Below are substantive changes to PCI 135, Specification for Tolerances of Precast Concrete, due to public comments. Changes are shown in redline/strikethrough format. Only these sections of the proposed document as available for a thirty-day public comment period.

Figure 4.3.6. Flat slab.

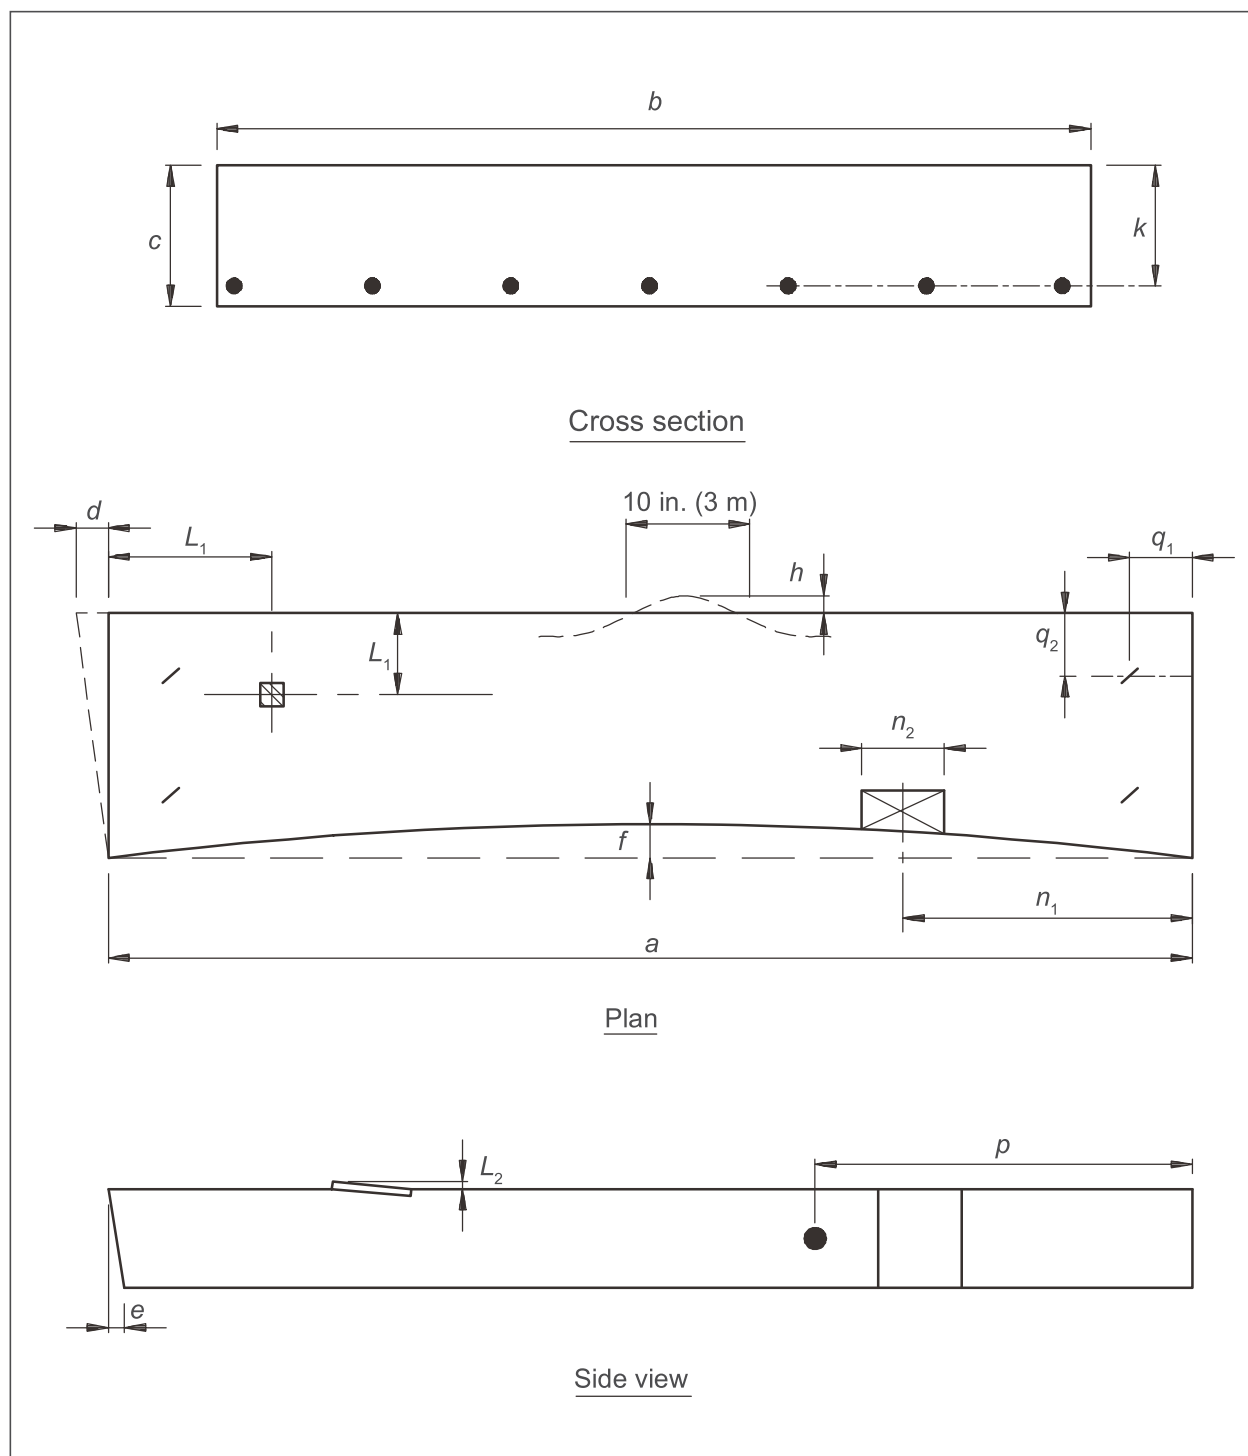
164 Public Comment #104 - Add Flat Slab production tolerances

4.3.6 Fabricate precast concrete solid flat slabs (Fig. 4.3.6) to the following production tolerances:

- a = Length $\pm\frac{1}{2}$ in. (± 13 mm)
- b = Width (overall) $\pm\frac{1}{4}$ in. (± 6 mm)
- c = Depth (overall) $\pm\frac{1}{4}$ in. (± 6 mm)

- d = Variation from specified plan end squareness or skew
 $\pm\frac{1}{4}$ in. per 12 in. width; $\pm\frac{1}{2}$ in. maximum
 (± 6 mm per 300 mm width; ± 13 mm maximum)

- e = Variation from specified elevation end squareness or skew $\pm\frac{1}{4}$ in. (± 6 mm)
- f = Sweep, for component length:
- Component length ≤ 40 ft (≤ 12 m). $\frac{1}{4}$ in. (6 mm)

- Component length > 40 to 60 ft (> 12 to 18 m) $\frac{3}{8}$ in. (10 mm)
- g = Camber variation from design camber. $\pm\frac{1}{4}$ in. per 10 ft;
 ($\pm\frac{3}{4}$ in. maximum (± 6 mm per 3 m; ± 19 mm maximum))

- g_1 = Differential camber between adjacent untopped components of the same design to receive topping
 $\frac{1}{4}$ in. per 10 ft; $\frac{3}{4}$ in. maximum
 (6 mm per 3 m; 19 mm maximum)

- g_2 = Differential camber between adjacent pretopped components of the same design
 $\frac{1}{8}$ in. per 10 ft; $\frac{3}{8}$ in. maximum
 (3 mm per 3 m; 10 mm maximum)

- h = Local smoothness of any surface $\frac{1}{4}$ in. per 10 ft (6 mm per 3 m)
- k = Location of reinforcing material $\pm\frac{1}{4}$ in. (± 6 mm)
- L_1 = Location of embedment ± 1 in. (± 25 mm)

- L_2 = Tipping and flushness of embedment $\pm\frac{1}{4}$ in. (± 6 mm)
- n_1 = Location of blockout ± 1 in. (± 25 mm)
- n_2 = Size of blockouts $\pm\frac{1}{2}$ in. (± 13 mm)

- p = Location of inserts for structural connections $\pm\frac{1}{2}$ in. (± 13 mm)
- q_1 = Location of handling device parallel to length of component ± 6 in. (± 150 mm)

- q_2 = Location of handling device transverse to length of component. ± 1 in. (± 25 mm)

Figure 5.3.4. Architectural wall panel or spandrel erection tolerances.

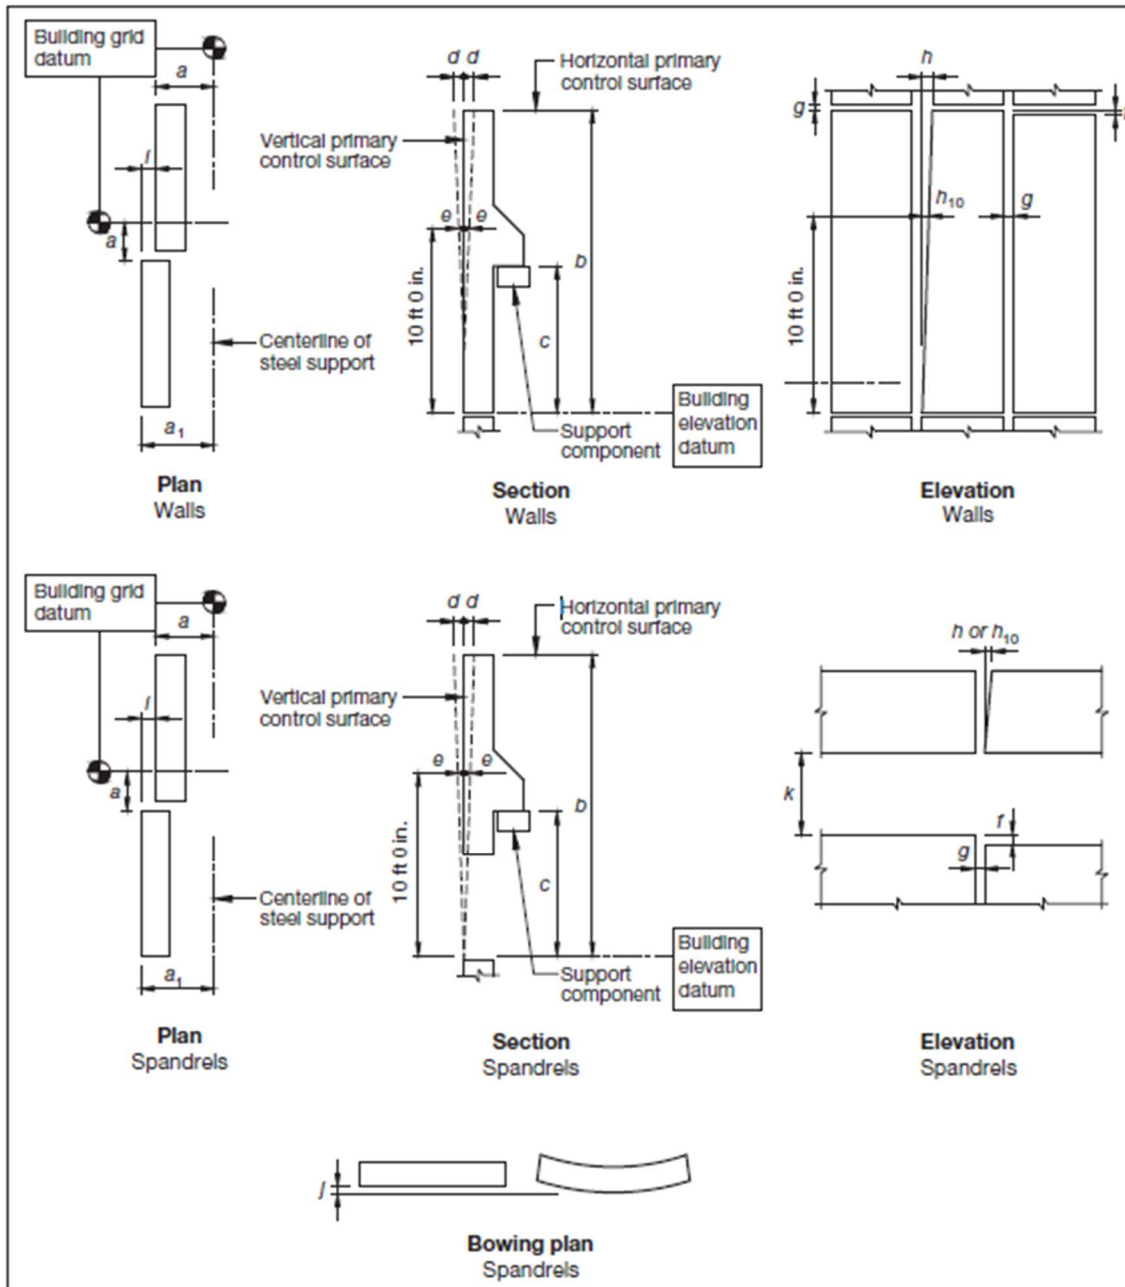
201 Public Comment #162 - match figures in MNL 117. Also reference Fig. 5.4.1

Add note at bottom of fig. 5.3.4: See Fig. 5.4.1 for GFRc panel erection tolerances.
